Correction of operation results in the report of “Plant data of
Fukushima Daiichi Nuclear Power Station at the time of
Tohoku-Chihou-Taiheiyou-Oki Earthquake”

June 13 2011

Tokyo Electric Power Company

Fukushima Daiichi Nuclear Power Station Unit 2 D/W pressure (MPa abs)

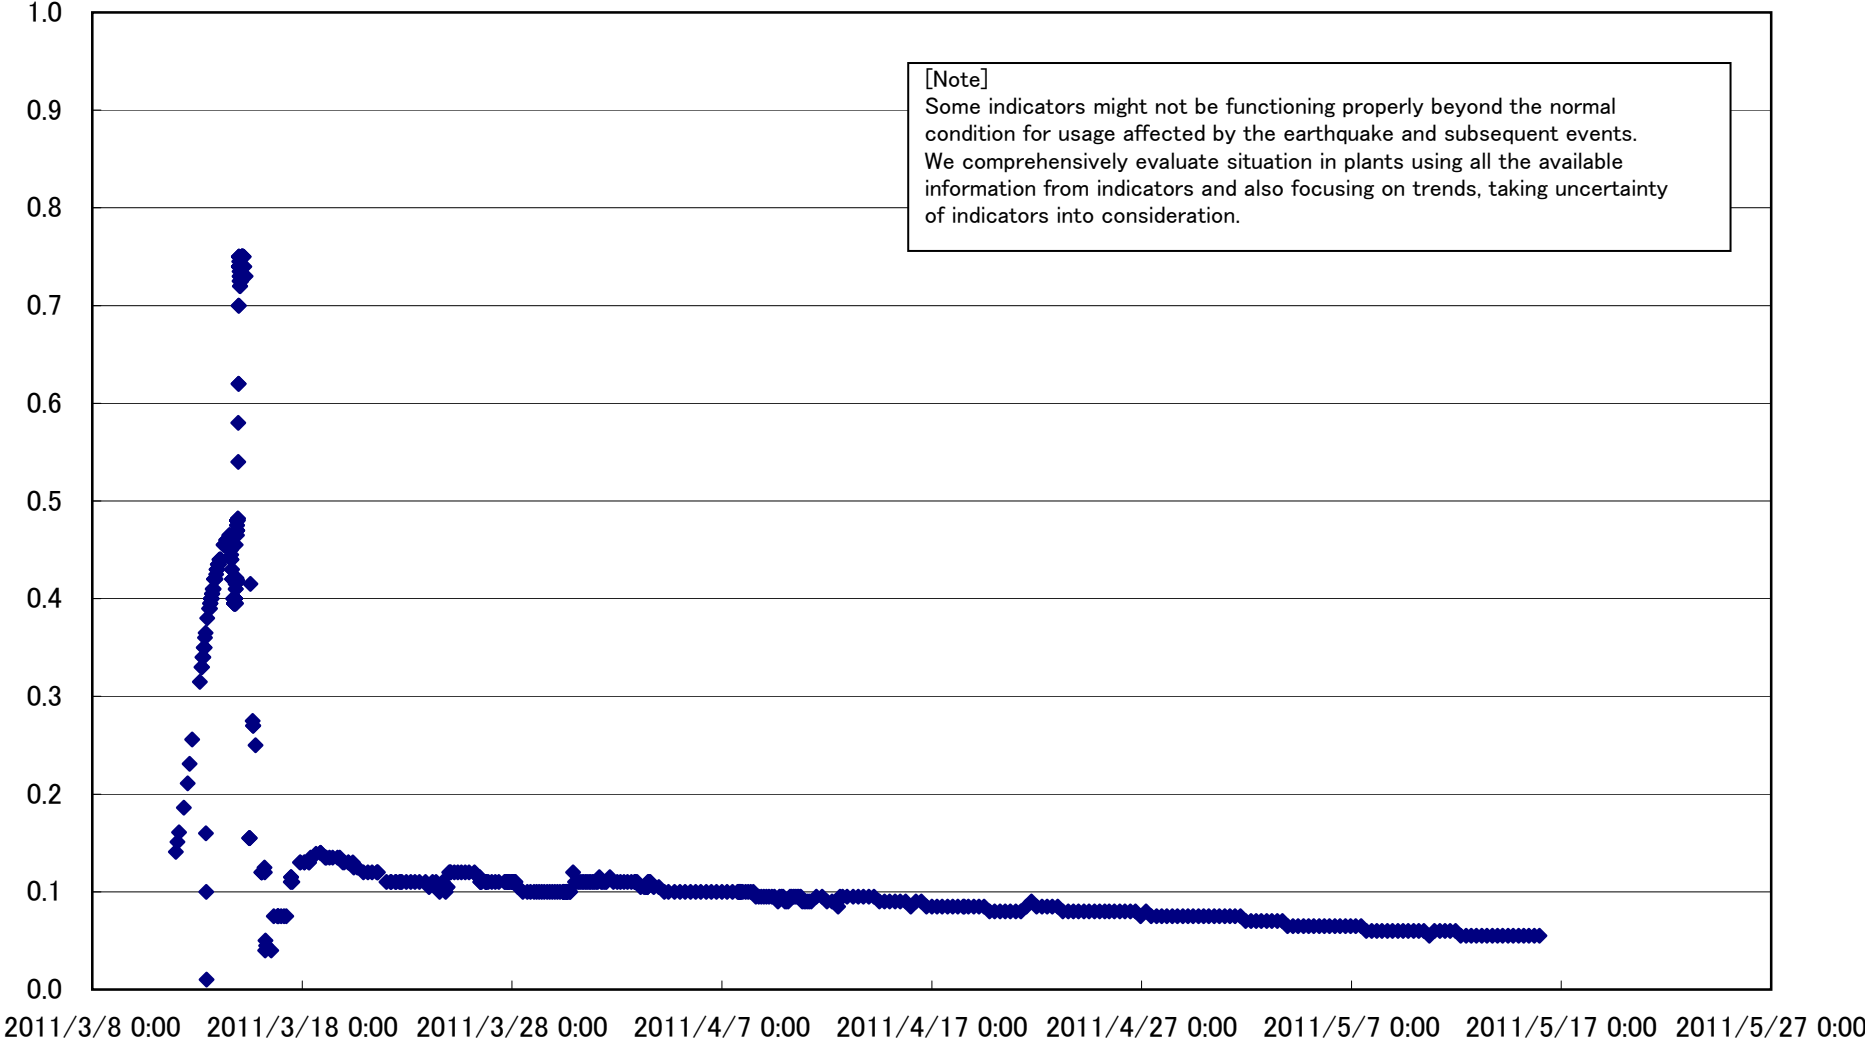
Before correction	After correction	Remarks
1F2 Water Level / Pressure		3/12 7:55 Remarks Change D/W Pressure gauge with abs	3/12 8:46 Remarks Change D/W Pressure gauge with abs	Correction of the difference of time
		3/12 9:30 Remarks Change D/W Pressure gauge with abs	3/12 12:55 Remarks Change D/W Pressure gauge with abs	Correction of the difference of time
		3/12 11:20 Remarks Change D/W Pressure gauge with abs	3/12 15:22 Remarks Change D/W Pressure gauge with abs	Correction of the difference of time
		3/12 13:26 Remarks Change D/W Pressure gauge with abs	3/12 18:20 Remarks Change D/W Pressure gauge with abs	Correction of the difference of time
		3/14 14:00 A System, Reactor pressure 7.639	3/14 14:00 A System, Reactor pressure 7.527	Correction of numbers
		2011/3/14 18:40 2011/3/14 18:39 2011/3/14 18:40	2011/3/14 18:39 2011/3/14 18:40	Deleted the duplicative data (the same date and time were in the data)

Fukushima Daiichi Nuclear Power Station Unit 2 S/C pressure (MPa abs)

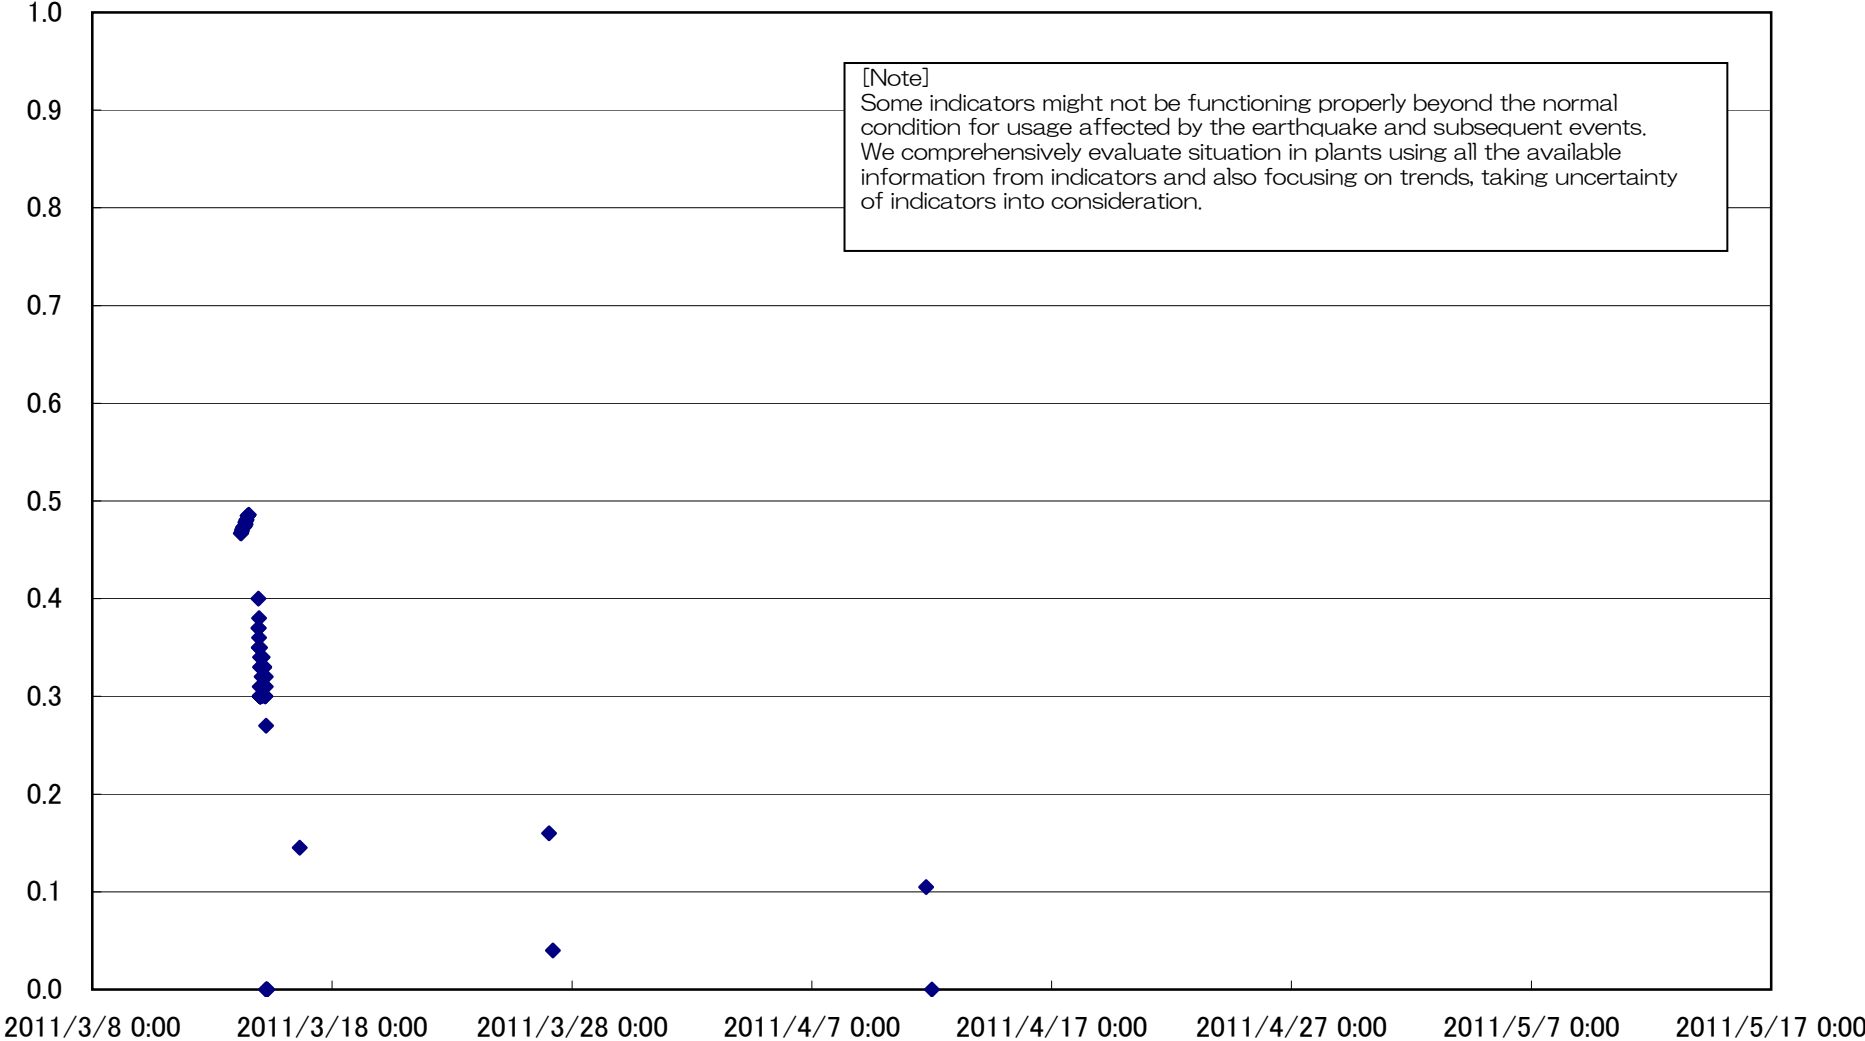
3/15 2:39 Remarks S/C Pressure Malfunction of equipment	3/15 11:25 Remarks S/C Pressure Malfunction of equipment	Correction of the difference of time
		2011/3/15 6:00	2011/3/14 6:00	Correction for clerical mistake of date
1F3 Water Level / Pressure		3/12 8:30 3/12 8:30	3/12 8:30	Deleted the duplicative data (the same date

Fukushima Daiichi Nuclear Power Station Unit3 Feedwater Nozzle N4B(°C)

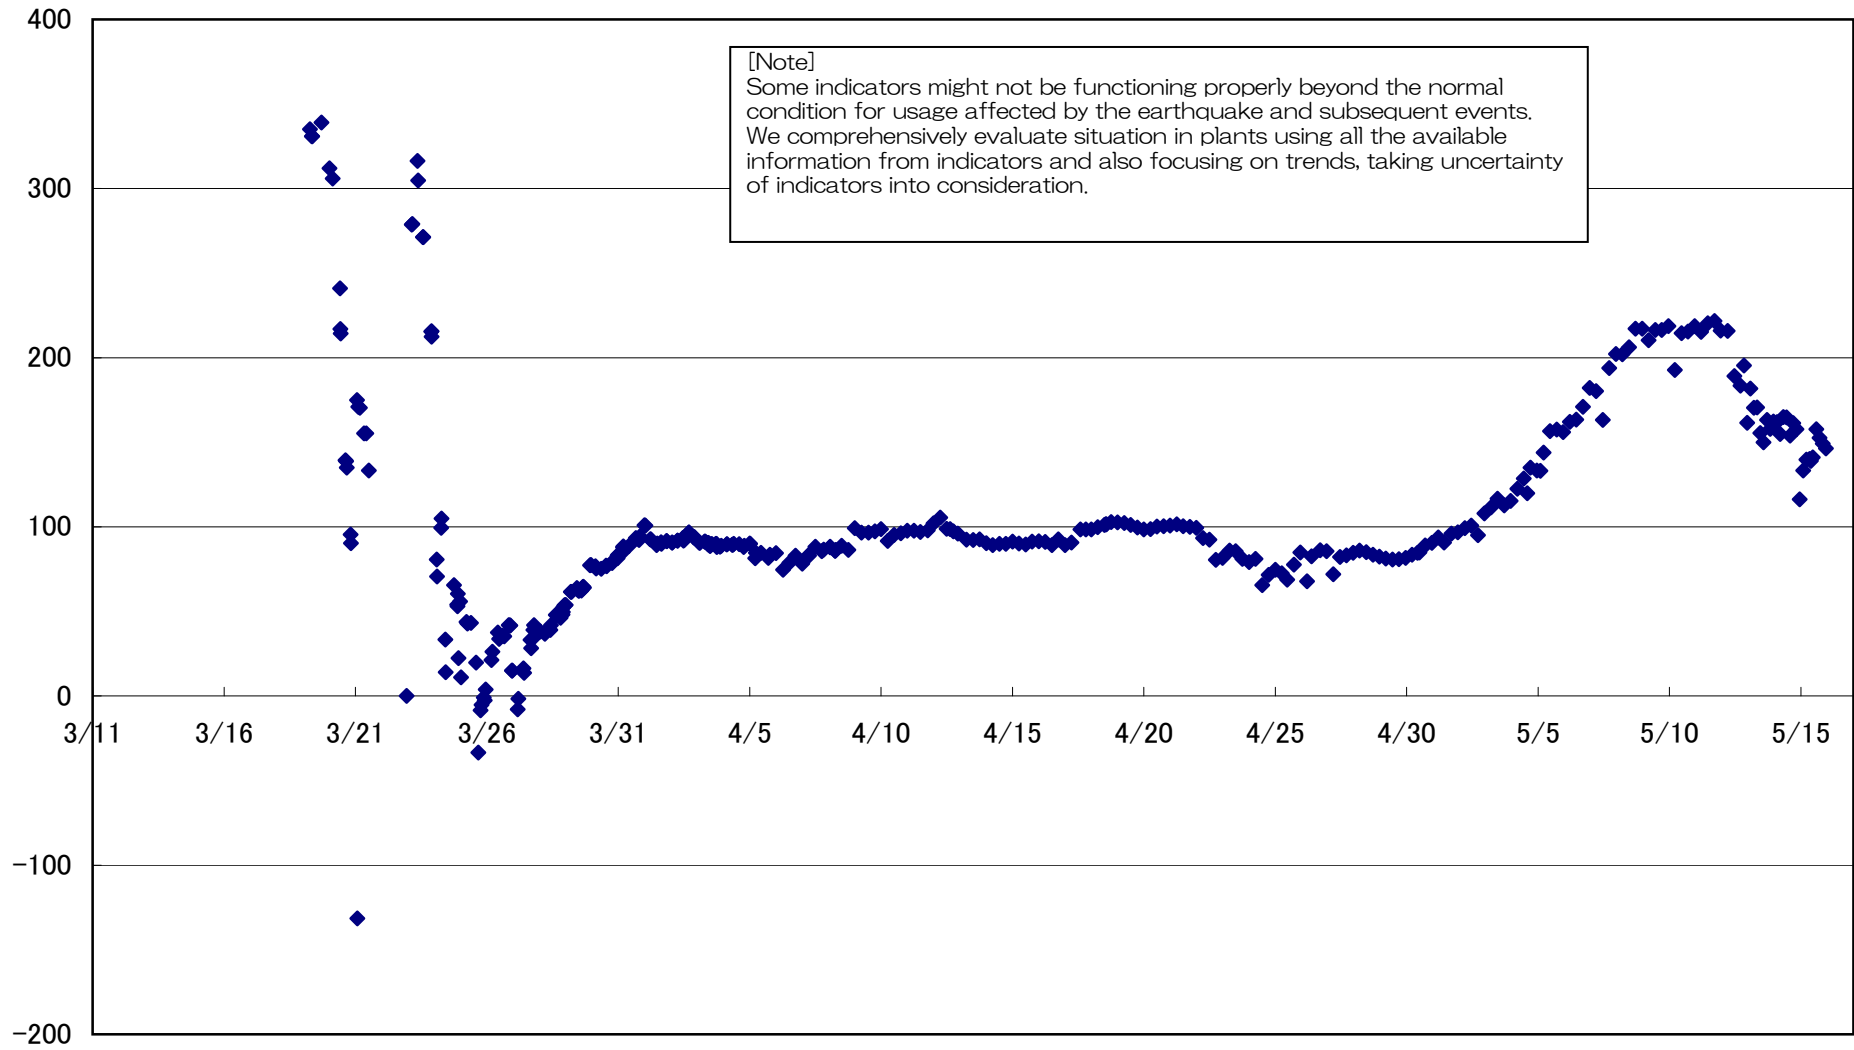
and time were in the data)
1F3temperature	3/20 10:35 Feed water nozzle N4Btemperature	3/20 10:35 Feed water nozzle N4Btemperature 214.4	Correction for data reflection
	3/21 10:00 D/W HVH back temperature 171.1	3/21 10:00 D/W HVH back temperature 167.2	Correction of numbers
	3/22 22:39		Deleted because there are no data in this time period
	3/24 6:45	3/24 6:35	Correction for clerical mistakes of time and date
	3/24 18:00 bottom of reactor pressure temperature155.7 3/24 18:00 bottom of reactor pressure temperature155.7	3/24 18:00 bottom of reactor pressure temperature155.7	Deleted the duplicative data (the same date and time were in the data)
